SERVICE BULLETIN

Subject: MDT3 and MDT4 Compressor Contactor

17-3349-01

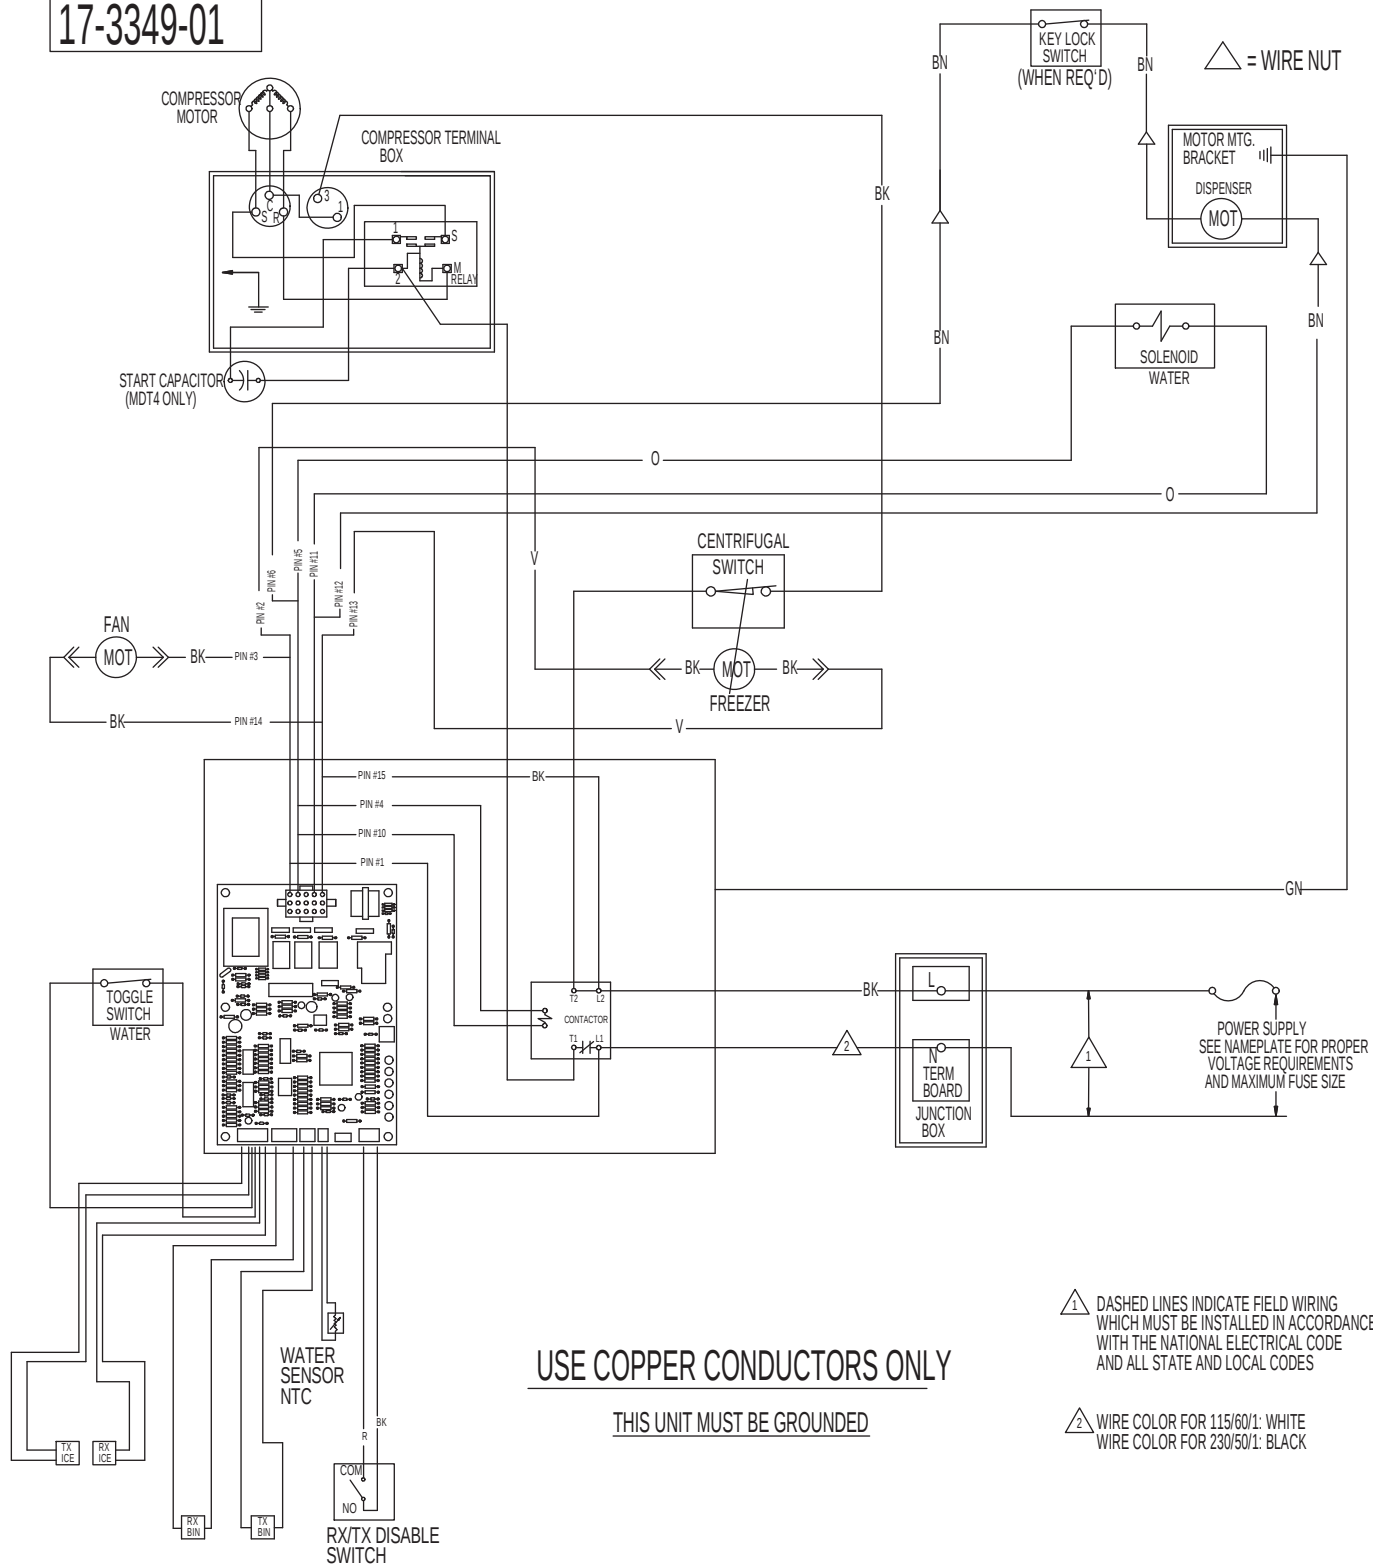
Beginning with MDT4F12A-1H serial number 11011320013662, a contactor has been added to operate the compressor. That unit was manufactured 1-27-11. MDT3F12A-1Hs manufactured after that serial number also have the contactor change. The contactor is located in a new, larger control box with the controller.

A wiring diagram is on the back of this bulletin.

- 12-2469-03 Contactor, 115/60/1
- 12-2469-02 Contactor, for 50 Hz model
- 12-3042-01 Wire harness for 60 Hz model w/contactor
- 12-3042-02 Wire harness for 50 Hz model w/contactor

The above kits do NOT include a new controller, when installing a kit the existing controller will be moved from the original box to the new one.
